**VALUE ENGINEERING SUMMARY
OF
US 119/BENT MT. TO COBURN MT.
WPI NO. 12-264.01
PIKE COUNTY, KENTUCKY**

DECEMBER 5-13, 1996

**Prepared by:
Ventry Engineering**

**Kentucky Transportation Cabinet,
Department of Highways**

SPLIT CONCEPT
2 of 2 VALUE ENGINEERING
 ALTERNATIVE

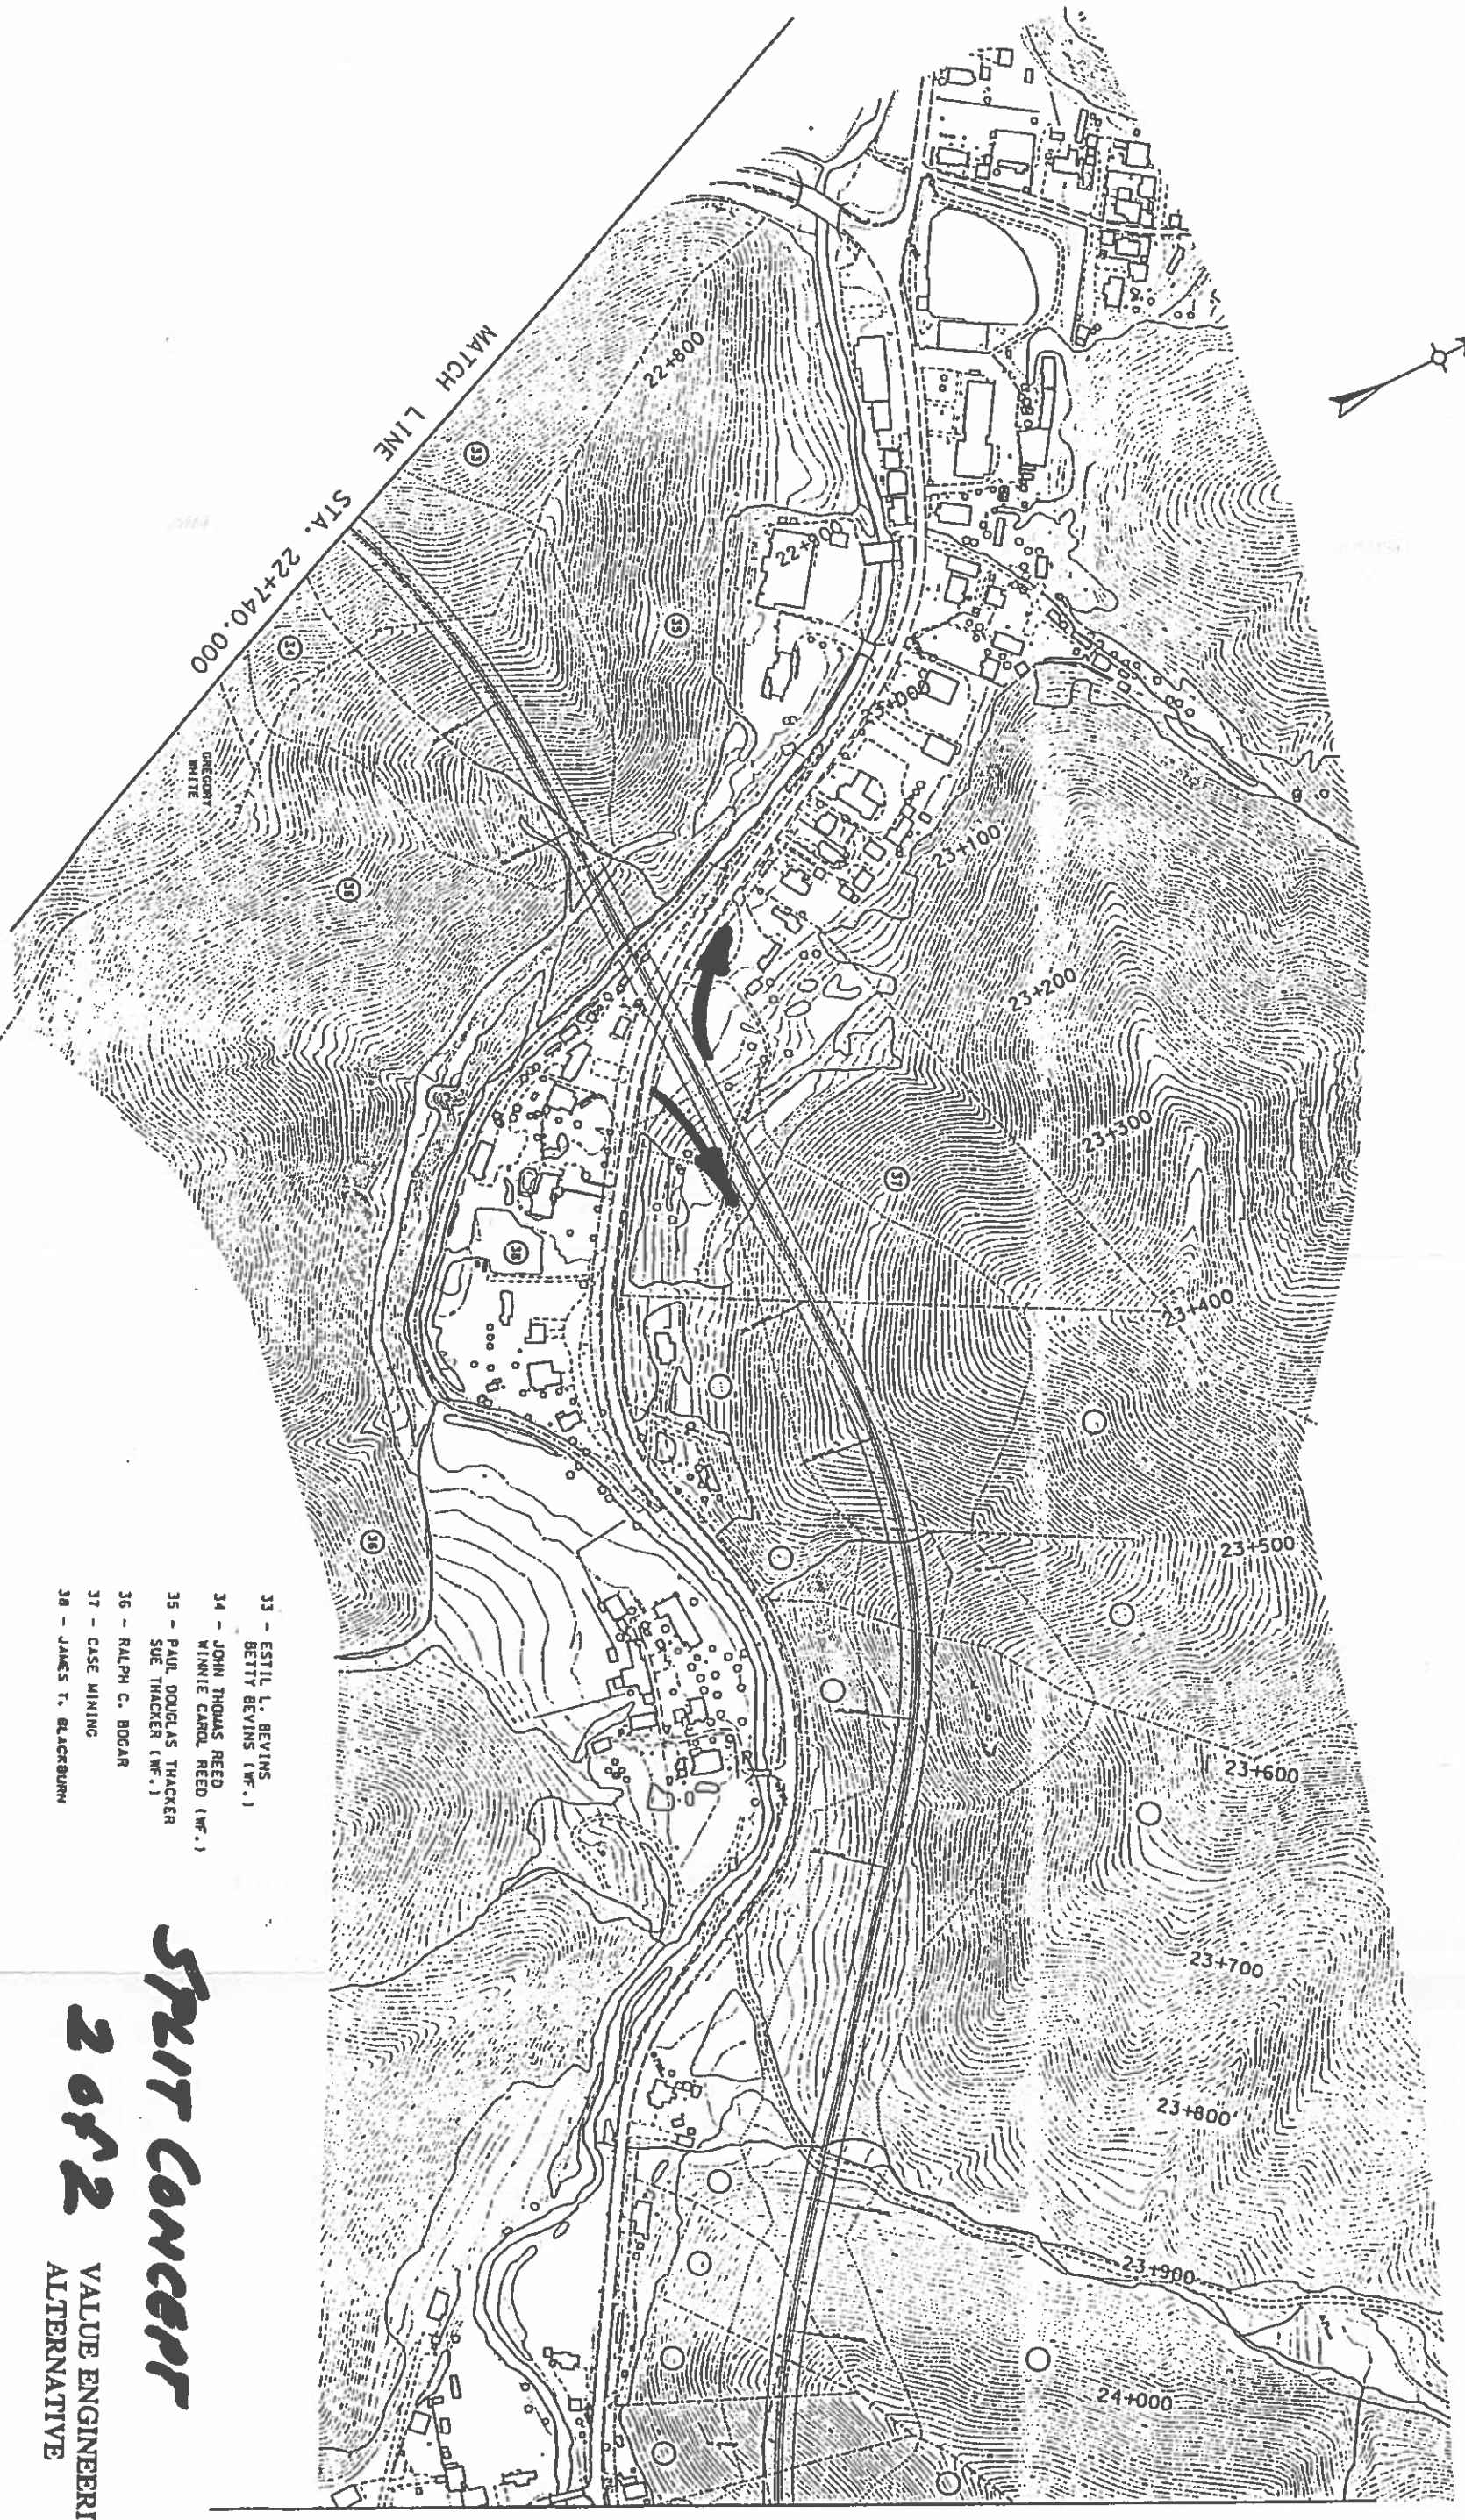
The team felt the ability to utilize the existing grade separations should offer an economical solution. During the evaluation phase this split concept dropped out as a result of the matrix evaluation. This was not carried forward to the development phase. During the presentation it was noted that the split concept interchange with the northbound exit located at Sta. 21 + 600; southbound entrance located at Sta. 22 + 500; and northbound entrance and southbound exit at Sta. 23 + 050, may have strong possibilities. This concept would require one additional structure for the SB on-ramp over Road Fork Creek at sta. 21 + 600. The grades as depicted upon first glance are workable with the southbound entrance ramp needing some acceleration lane requirements.

Concept 1

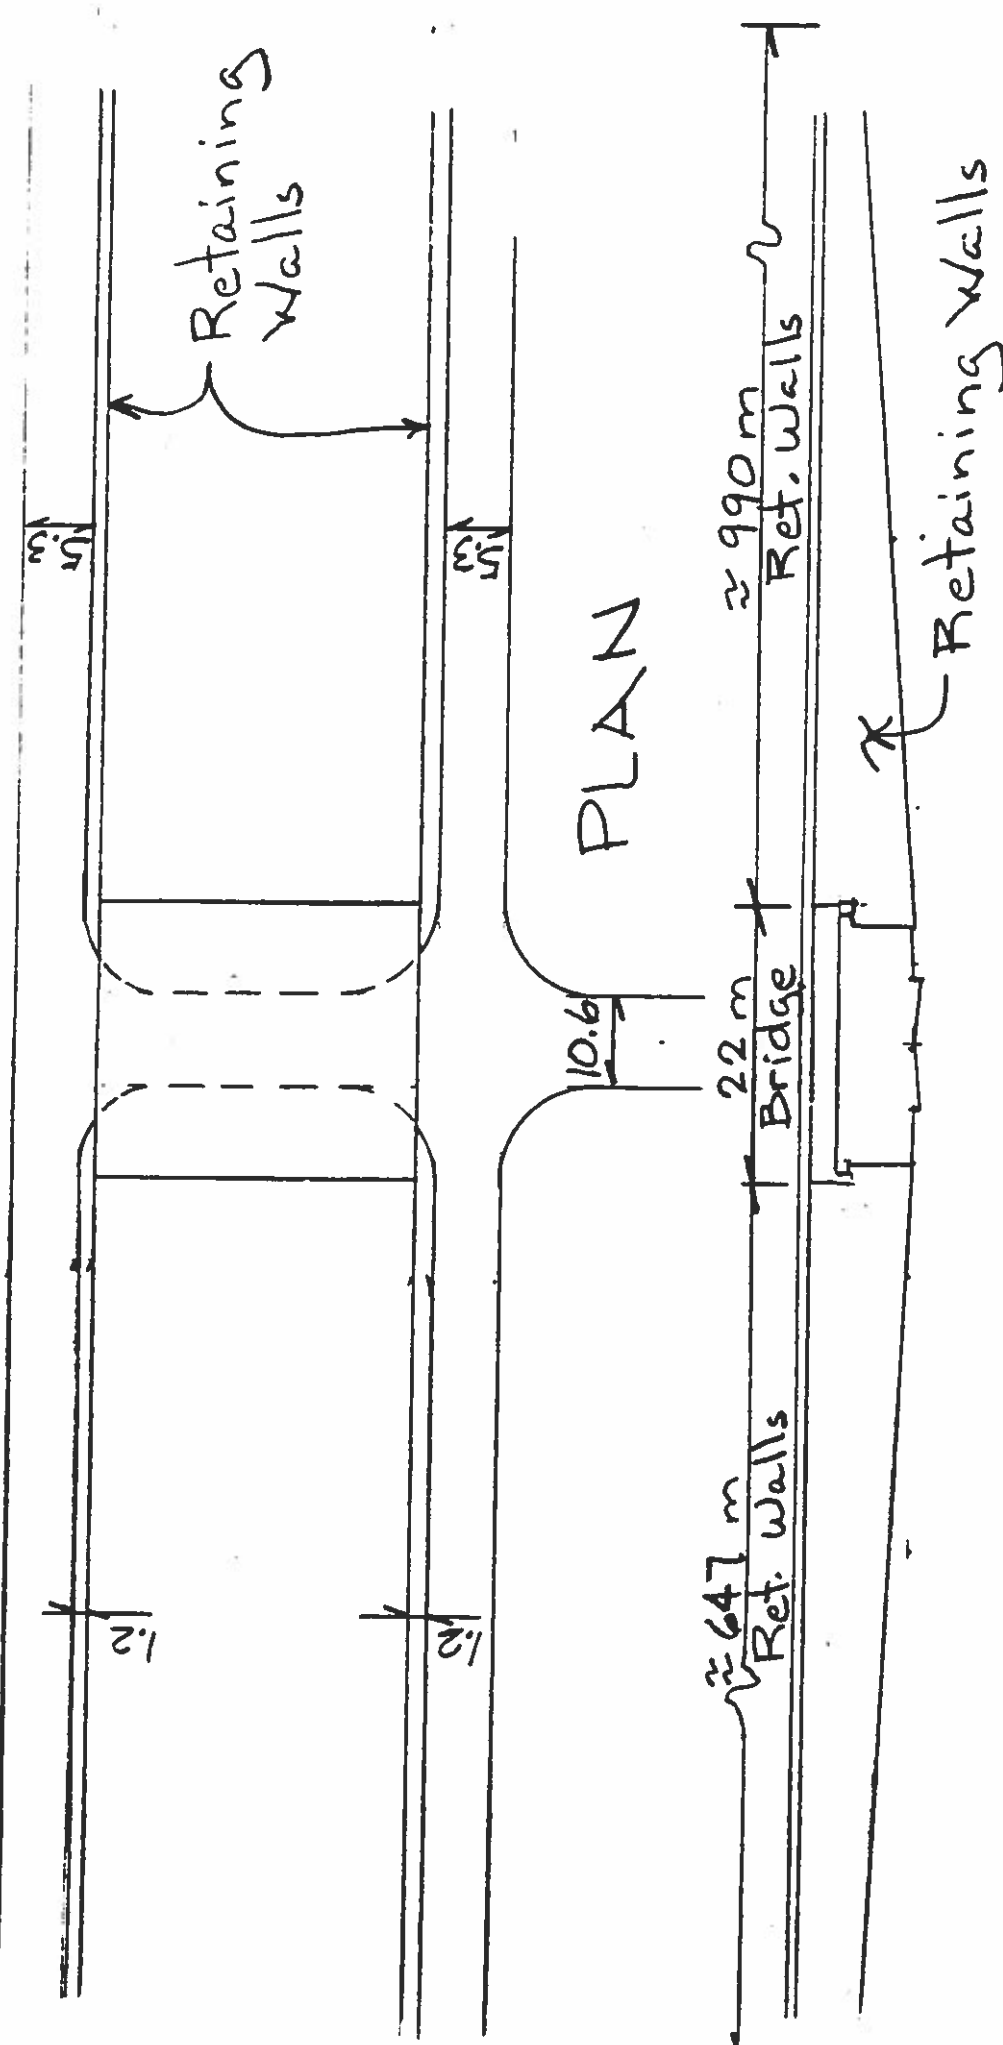
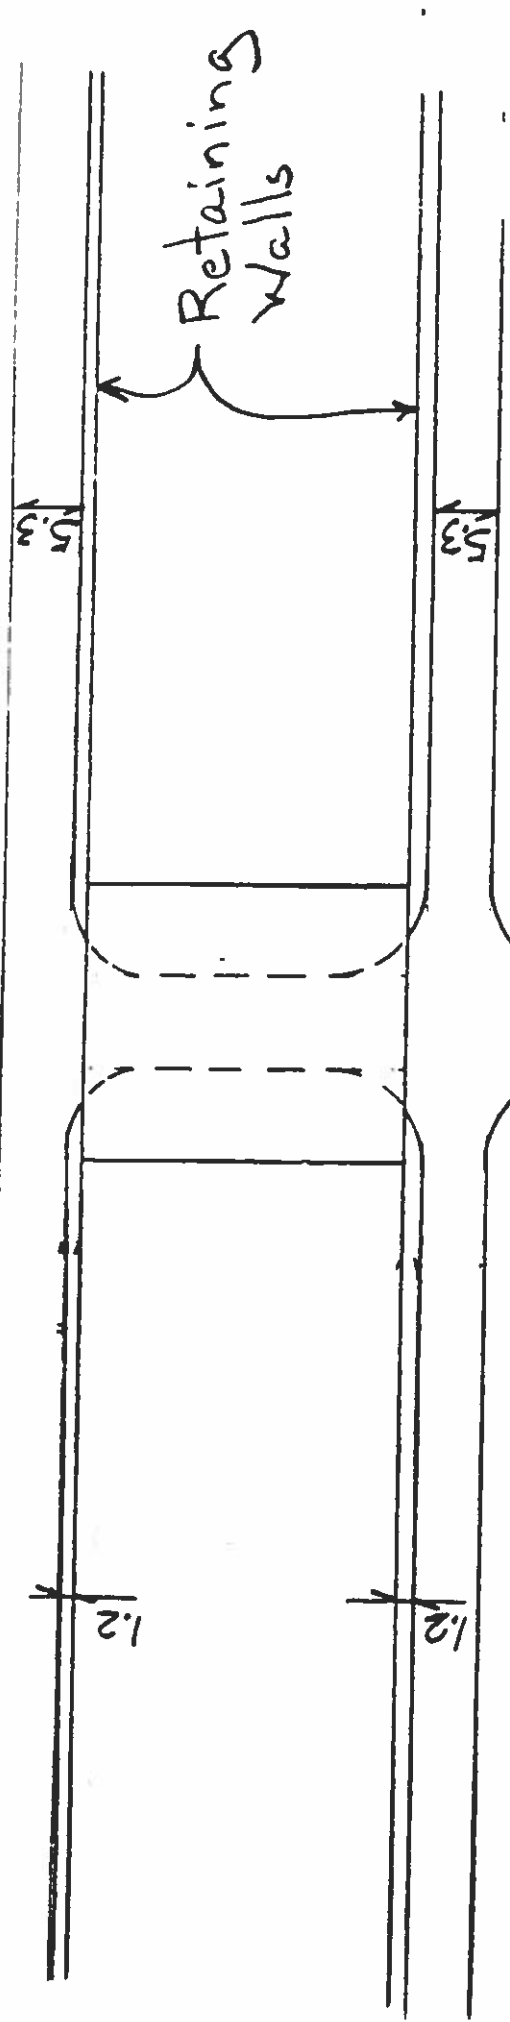
This concept involved the shortest bridge with walls carrying mainline over the access road. It did require the highest grades from the existing U.S. 119 to the interchange site. This team felt the 105 meter distance at a 8% grade could be undesirable with the high coal truck traffic. The cost was estimated at an additional \$14,751,000.

Possible Additional Cost \$14,751,068

Concept 2

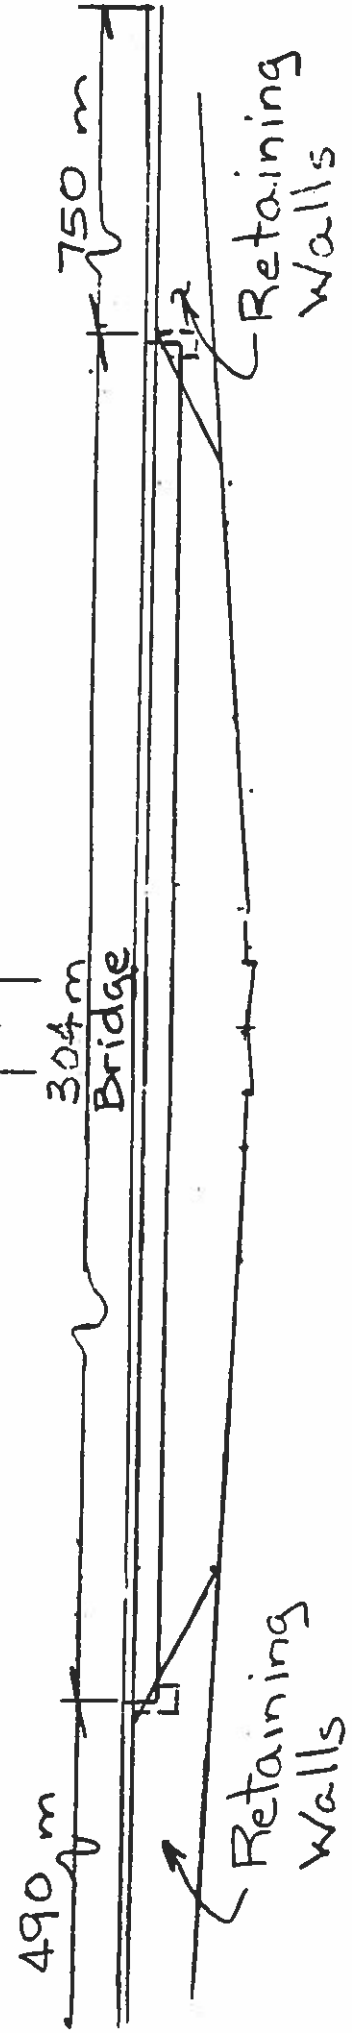
This concept required a longer bridge due to the limitation of MSE wall height to ten meters. This alternative increase the cut volume also. This concept would require an increase in cut material. The cost was estimated to be \$16,790,000 more than the at grade intersections.

Possible Additional Cost \$16,790,068

ELEVATION
(Single Span Type III)
Concept 3

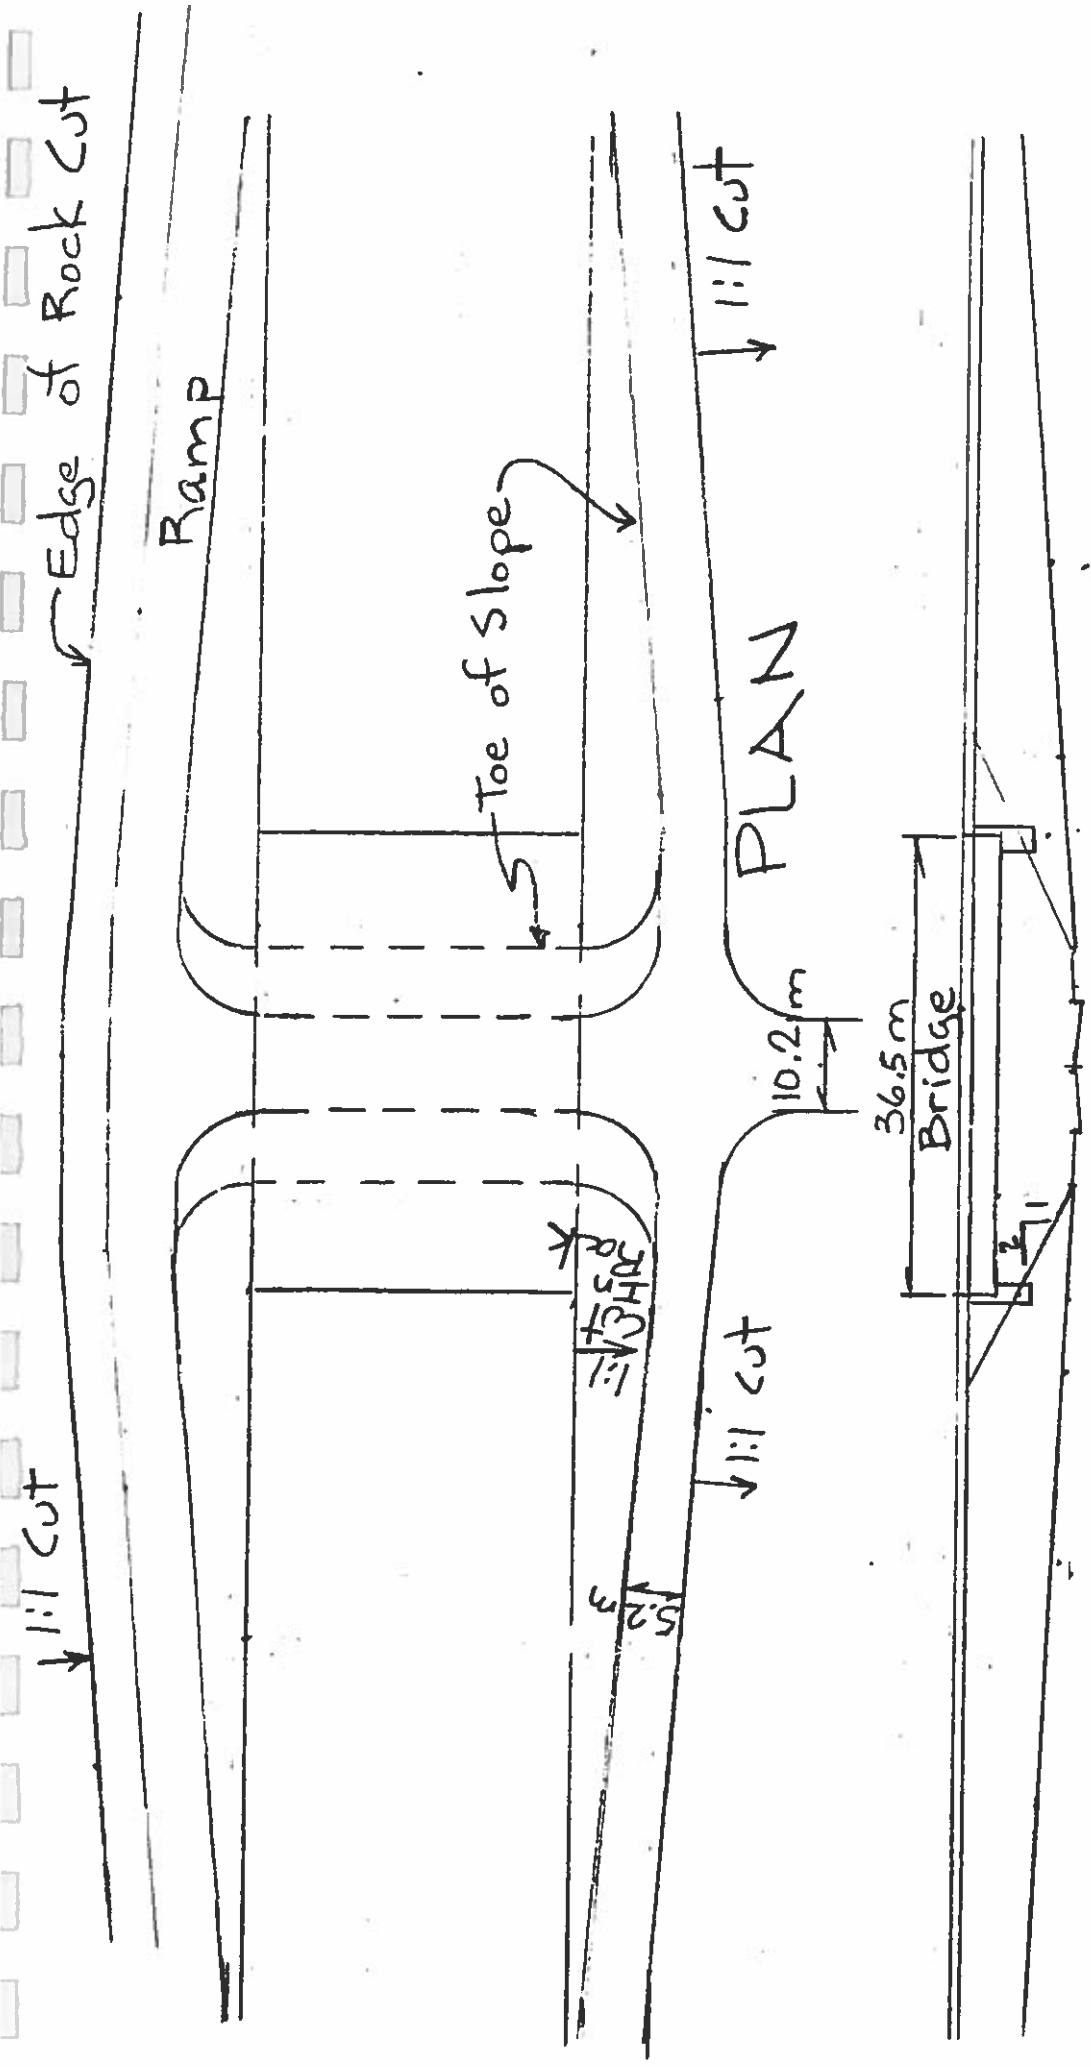
This concept came about after noticing the total wall and bridge cost for either of the two above described concepts was between 11 and 12 million dollars.

The last quick look at interchanges involved the use of spill through abutments at the bridge ends and side slopes. The foot print of this interchange is much larger than the previously discussed alternatives. The cut material dramatically increases with the project cost increasing by \$11.8 million. This cost is being driven by the cut volume and spoil area location.

Possible Additional Costs \$11,890,068
